JEFFERSON COUNTY
LAW ENFORCEMENT CENTER
JEFFERSON, WISCONSIN

GROUND FLOOR PLAN

AS BUILT
DEC 6, 1994

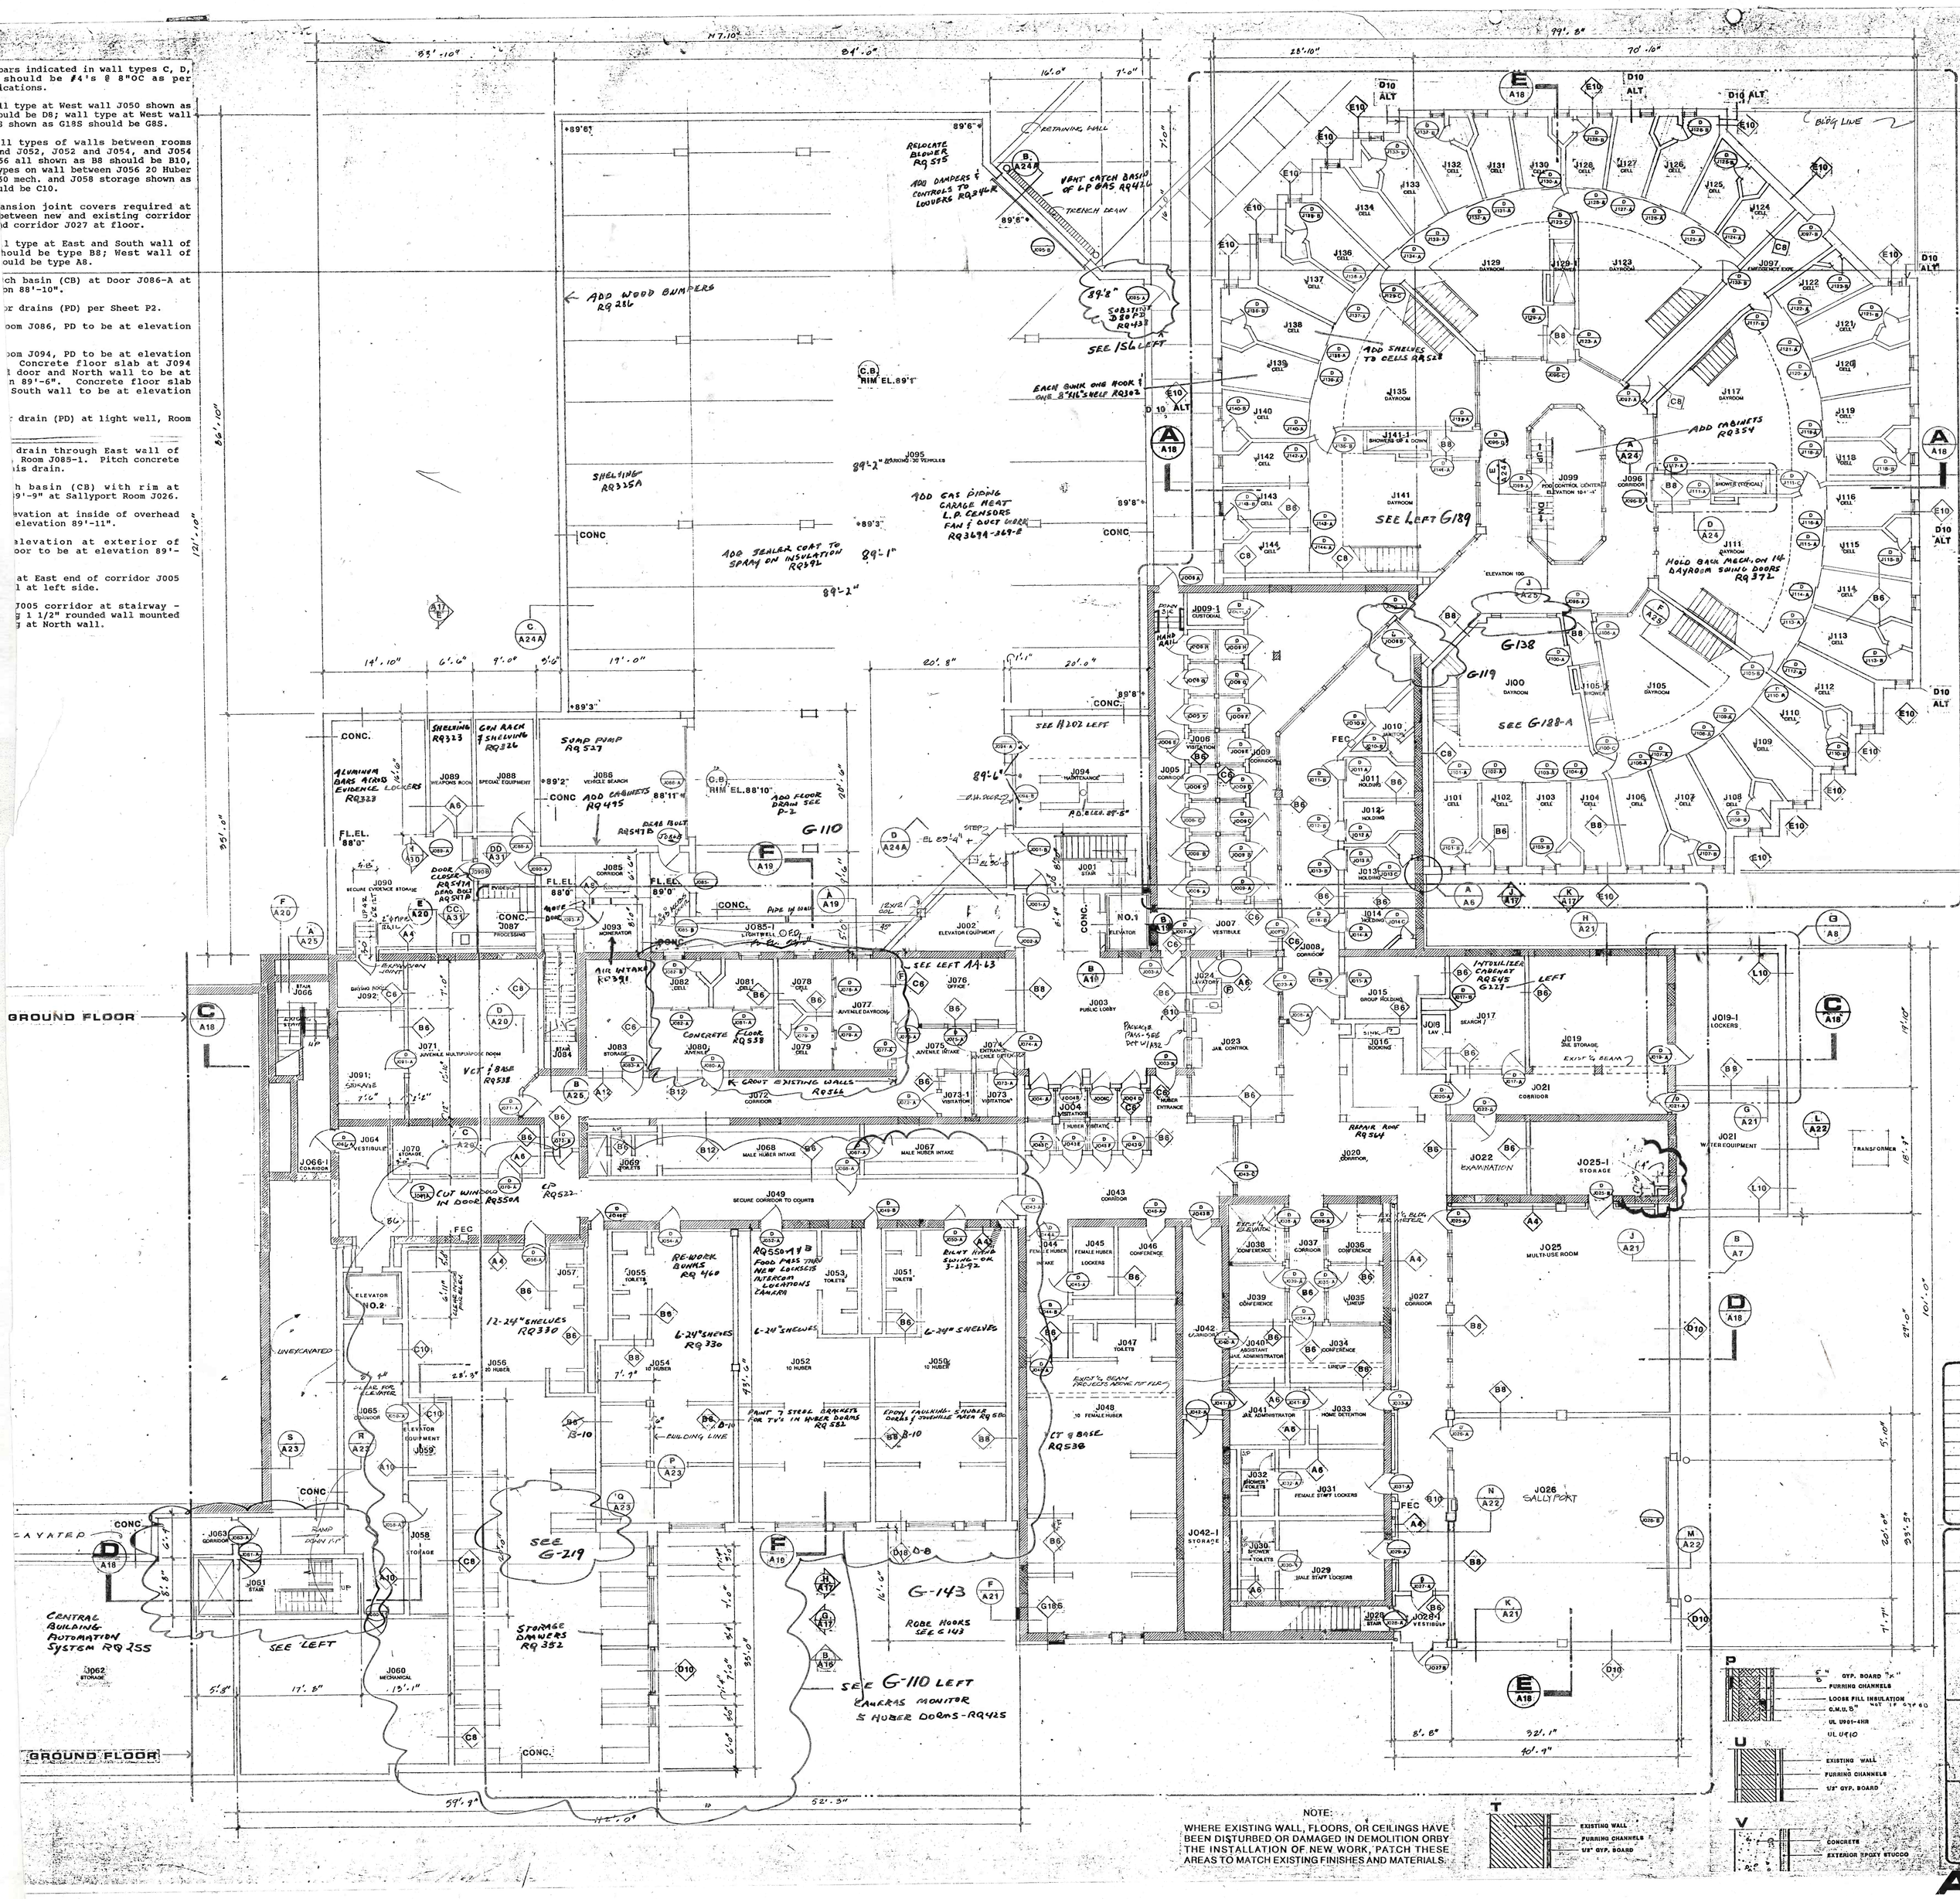
bars indicated in wall types C, D, should be #4's @ 8"OC as per ications.

ll type at West wall J050 shown as uld be D8; wall type at West wall shown as G18S should be G8S.

ll types of walls between rooms nd J052, J052 and J054, and J054 56 all shown as B8 should be B10, ypes on wall between J056 20 Huber 50 mech. and J058 storage shown as ld be C10.

ansion joint covers required at between new and existing corridor d corridor J027 at floor.

l type at East and South wall of hould be type B8; West wall of ould be type A8.

ch basin (CB) at Door J086-A at on 88'-10".

r drains (PD) per Sheet P2.

oom J086, PD to be at elevation

om J094, PD to be at elevation Concrete floor slab at J094 l door and North wall to be at n 89'-6". Concrete floor slab South wall to be at elevation

drain (PD) at light well, Room

drain through East wall of Room J085-1. Pitch concrete is drain.

h basin (CB) with rim at 9'-9" at Sallyport Room J026.

evation at inside of overhead elevation 89'-11".

elevation at exterior of oor to be at elevation 89'-

at East end of corridor J005 l at left side.

J005 corridor at stairway - g 1 1/2" rounded wall mounted g at North wall.

DATE	
	1. Provide expansion joint covers at the following locations: Public lobby J003 at joint between new and existing floor from elevator No. 1 and elev. equip. room J002; between corridor J008 and corridor J096 floor joint shall follow a line under doors J008B and J008J, in corridor J049 at elevator No. 2 entrance, floor joints will follow line of existing wall; doors J019-A and J021-A at floor joint only. Floor joints and joints around door opening shall be as detailed in Addenda Drawing AA45 at the following doors: J025-B, J028-A, J029-A, J031-A, J033-A, J050-A, J052-A, J054-A, J056-A, and J092-A.

STRUCTURAL CONSULTANT
Room J009-1 Custodial may be used for pneumatic door operating equipment
